RE: 8004 Fuji Ct NW
Grading and Drainage Plan
Engineer's Stamp Date: 1/23/26
Hydrology File: E10D088
Case # HYDR-2025-00003

Thank you for your re-submittal and comments. Based upon the information provided in your re-submittal 1/27/2026, the Grading and Drainage Plan **is not approved** for Grading Permit and Building Permit. The following comments were marked as addressed but aren't reflected in the plans for the referenced project.

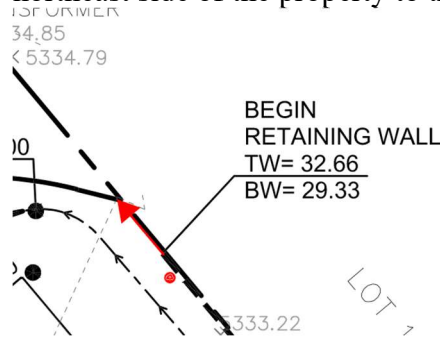
1. Thank you for updating the pond narrative. Per my last comments please update SAD 228 to SAD 227.

ENGINEER'S SEAL	LOT 13 BLK 13 U 5 VC 8004 FUJI CT. NW GRADING AND DRAINAGE PLAN	DRAWN BY DEM
		DATE 10-8-20
1/23/26		SHEET # C1
DAVID SOULE P.E. #14522		JOB #

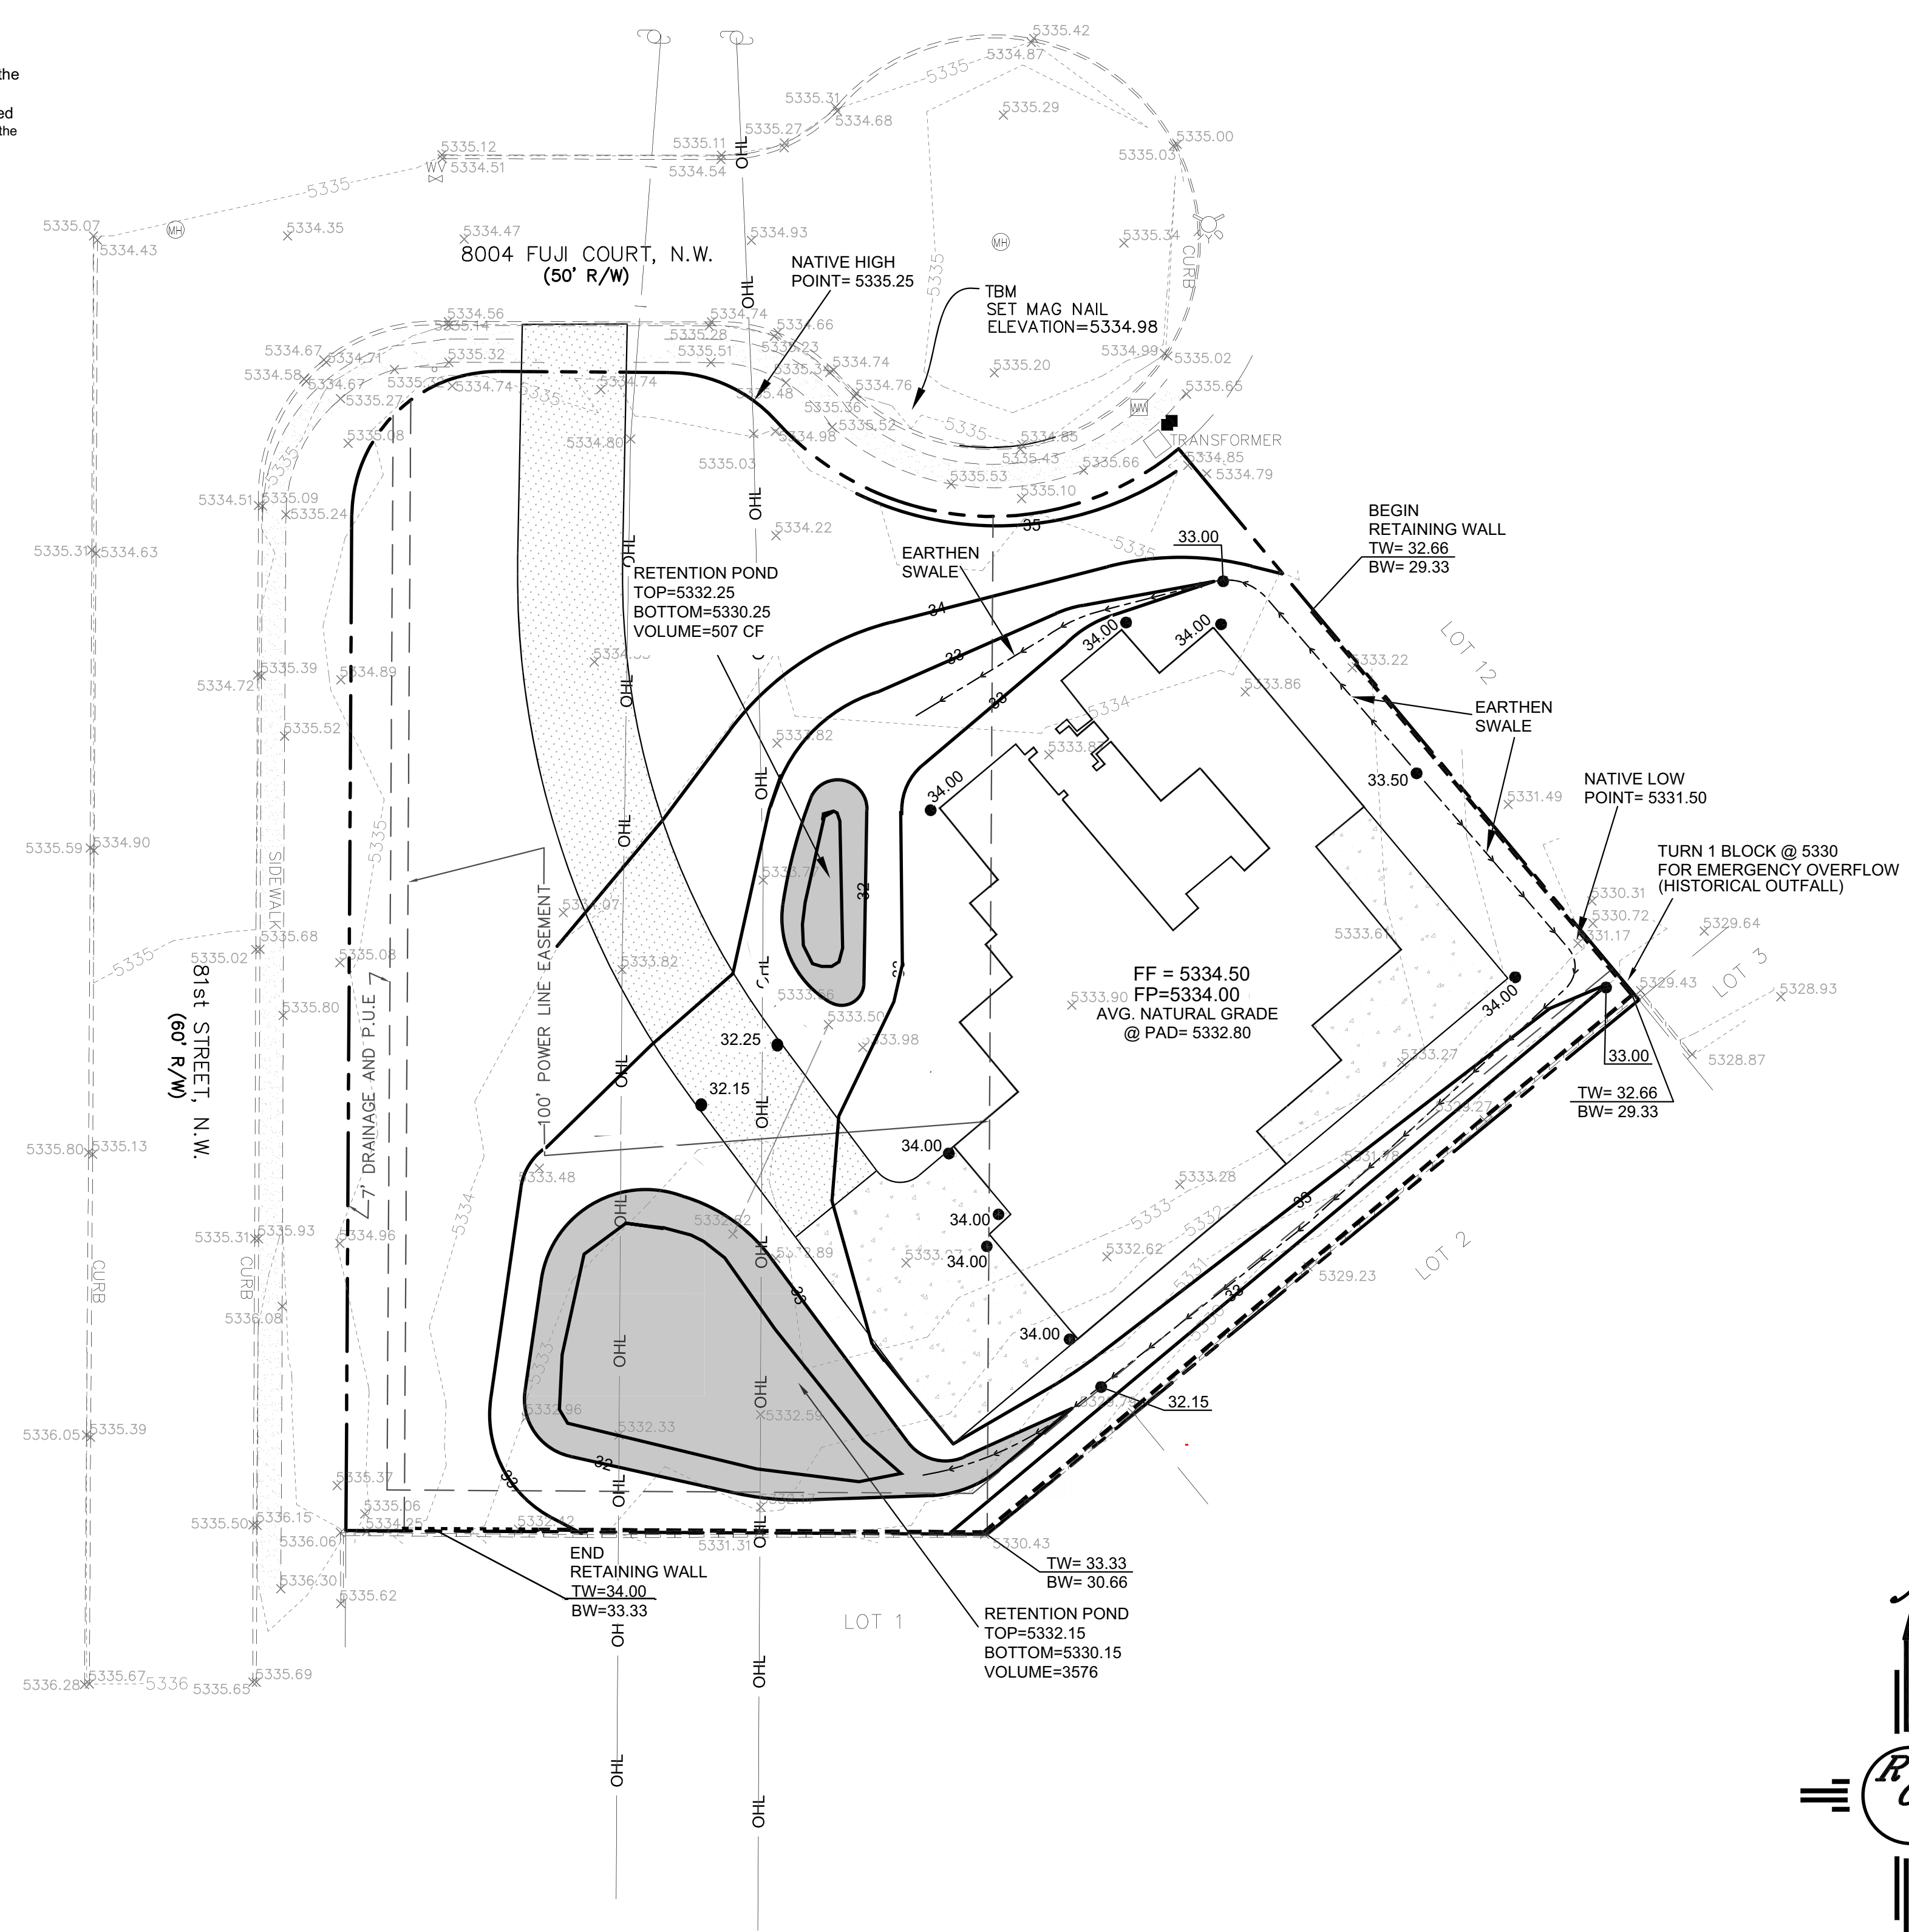
2. The retaining wall is still shown set back from the 5334' contour in the plans. Per previous comments and our phone call on 1/22/26, please extend retaining wall on the northeast side of the property to the 5334' contour line.
